RE: Vermejo SWD #1 30-015-40644 (SWD-1321-0) Subject:

I have reviewed the information submitted to the Bureau regarding the two items listed in the Administrative Order SWD-1321 as prerequisites for approval of injection in this well (swab test for hydrocarbon and water analysis). The information includes a letter report, well completion diagram, a cross-section utilizing information of Judah Oil's Red Lake State SWD #1 (SWD-332-A; formerly Lucas Store "KT" State Com #1), and water analysis for proposed injection from Blinebry/Paddock producers.

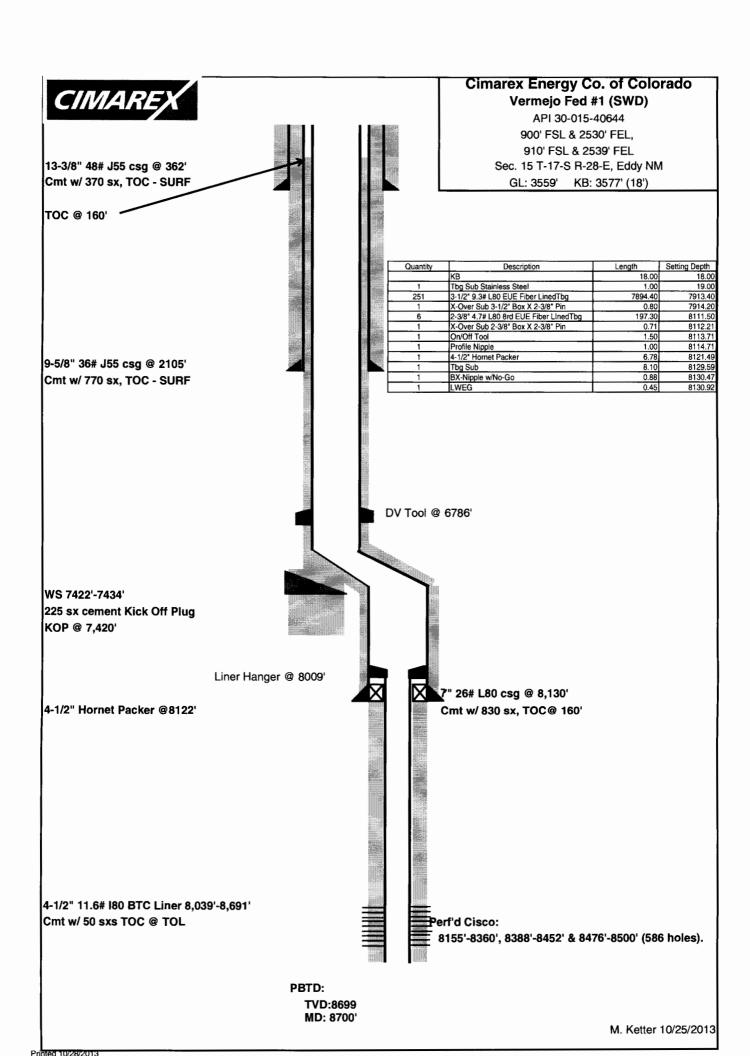
The information in the letter report concerning the well completion supports the lack of any potential for hydrocarbon shows had a swab test been conducted. The presentation of the cross-section and the associate discussion regarding geology and formation characteristics of the Cisco in this area is adequate to provide a correlation of water quality. With the information provided by Cimarex, the Bureau has decided that the two prerequisites requirements have been sufficiently addressed and that the District may proceed with approval for injection if there are no remaining issues to be resolved. The report along with this e-mail will be posted in the SWD order image file. If there questions concerning this subject, please contact me at your convenience. PRG
